H. B. ROBINSON STEAM ELECTRIC PLANT UNIT NO. 2

AMENDMENT TO FACILITY OPERATING LICENSE

Amendment No. 41  
License No. DPR-23

ATTACHMENT TO LICENSE AMENDMENT NO. 41

Figure 6.2-1  
6.2-3

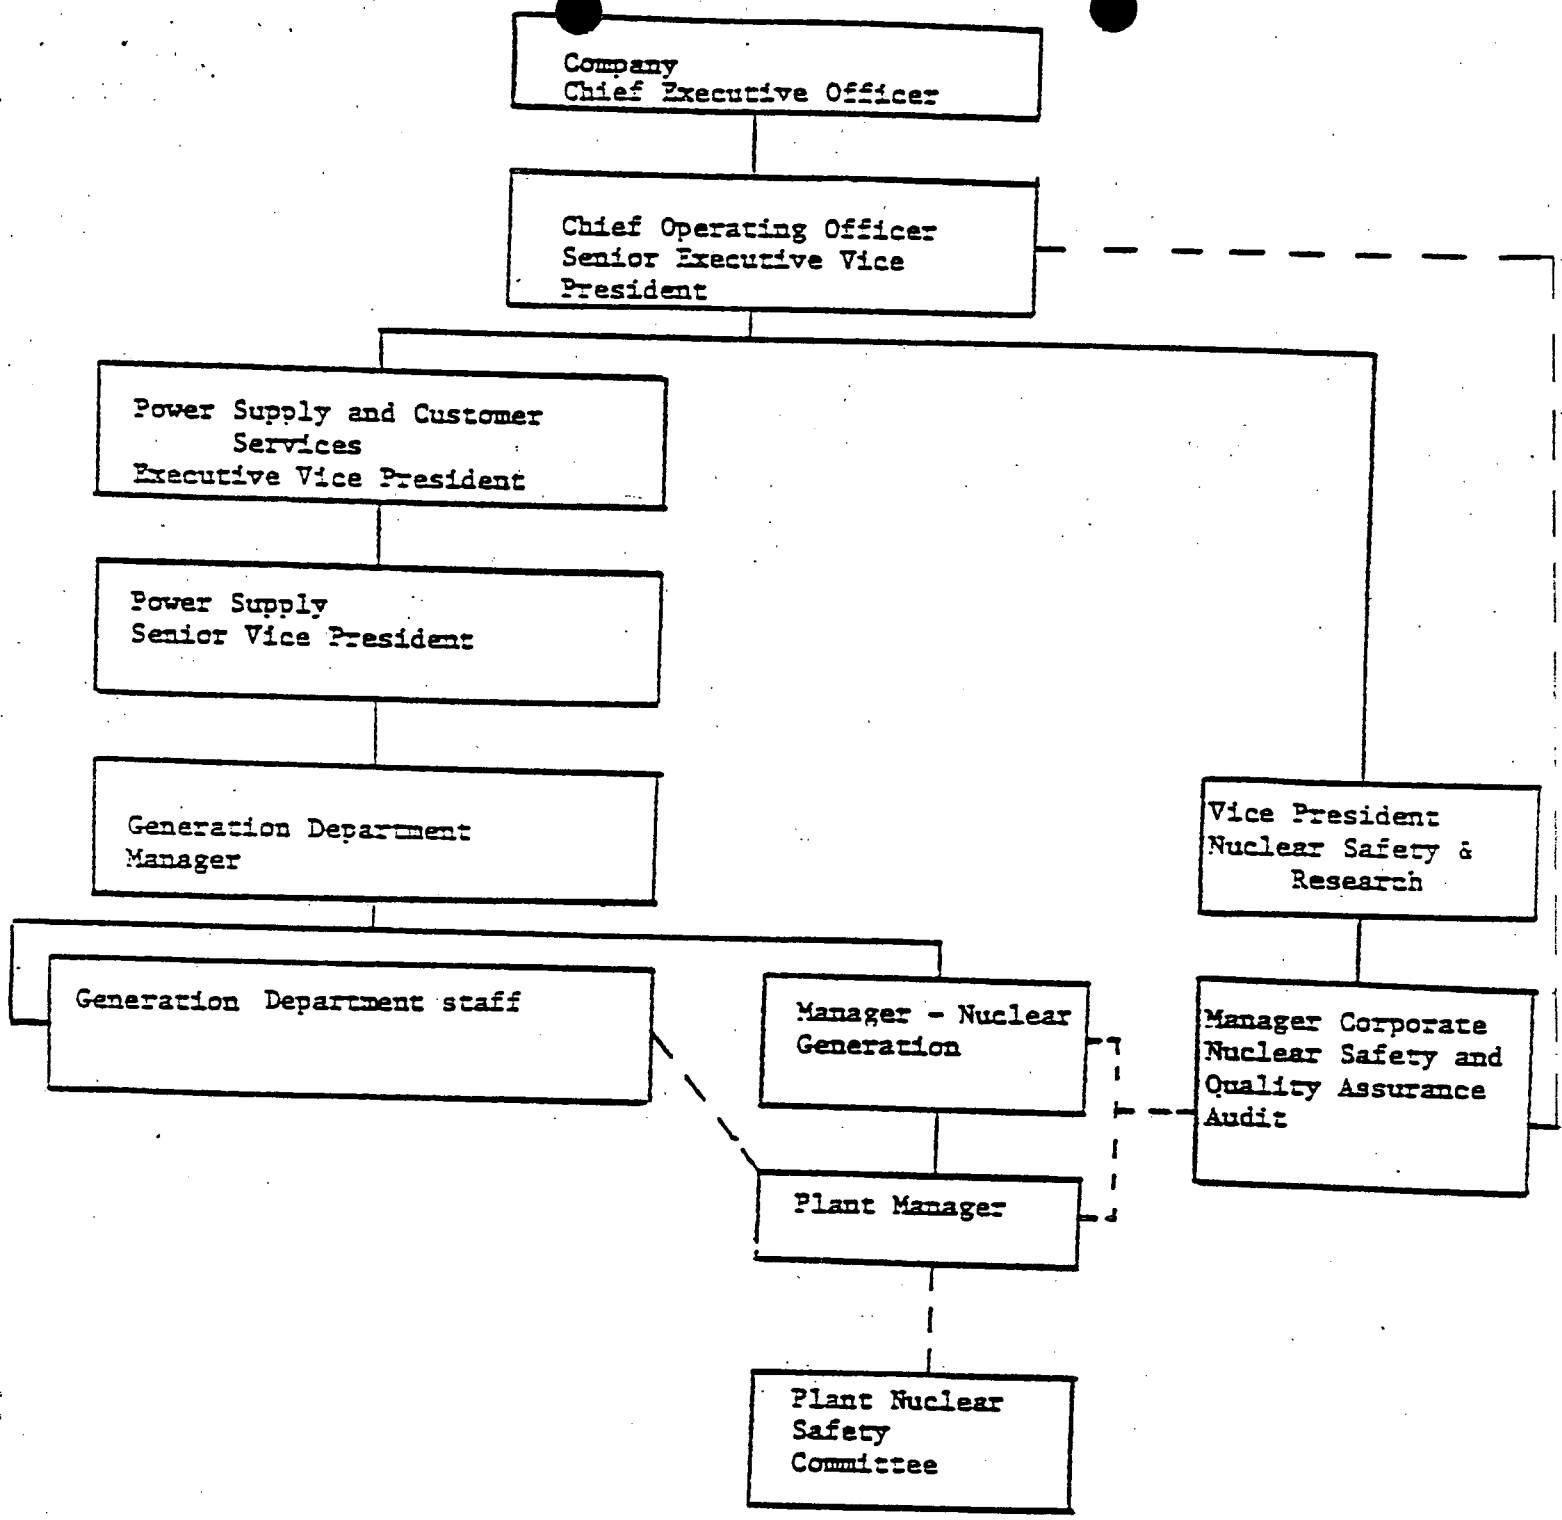
Replace the following pages of the Appendix "A" Technical Specifications with the enclosed pages. The revised pages are identified by amendment number and contain vertical lines indicating the area of change.
